# Groundwater Application Review Summary Form

Application # G- 19393

GW Reviewer Joe Kemper Date Review Completed: 8/1/2024

**SUBJECT: Scenic Waterway Interference & General/Local Surface Water Evaluation for Deschutes Ground Water Study Area**

**Hydrograph One:** Groundwater Level Elevations from the Cascade Foothills to Northeast Bend. The box indicates the water levels that the proposed POA will likely encounter.

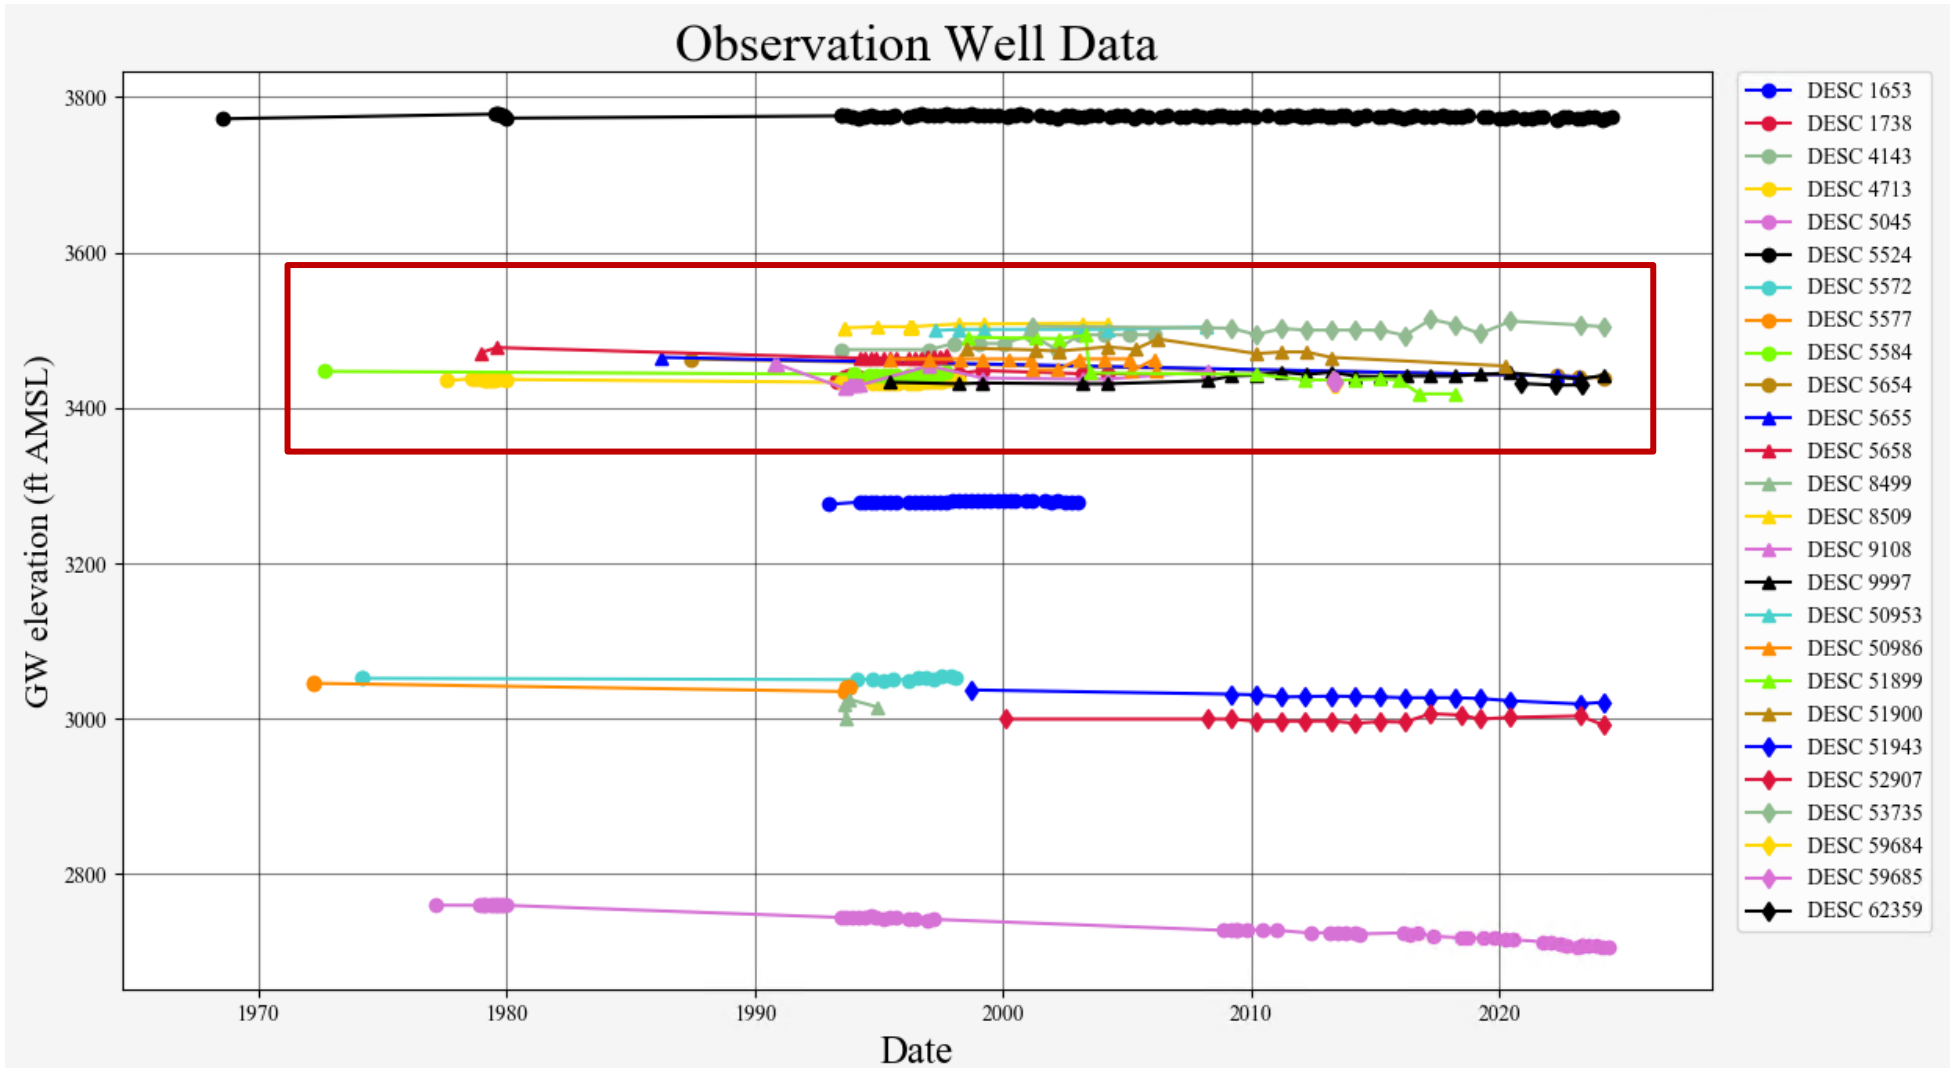
B3. **Groundwater availability remarks:** The applicant’s well will penetrate mixed Cascade-sourced Quaternary volcanics and then access the Deschutes aquifer hosted within the Deschutes Formation. The groundwater gradient flows from southwest to northeast. Water level elevations in adjacent observation wells are 3430 to 3470 feet AMSL. Water levels have very little season fluctuation. Water level records are intermittent and often have coarse precision which creates uncertainty in discerning trends in the aquifer. Water levels in DESC 4713, DESC 5658, and DESC 5584 rise several feet in response to high precipitation periods (e.g. 1996). DESC 5654 and DESC 5655 show 20+ feet of decline since the mid-1980s, but other observation wells do not show decline. There is some concern with persistent declines due to increasing pumping and decreasing climate recharge, however the preponderance of evidence does not show high-magnitude year on year declines that would rise issues of Capacity of the Resource. The above conditions are recommended; there is a strong emphasis on accurate and consistent water level measurements at the proposed well.
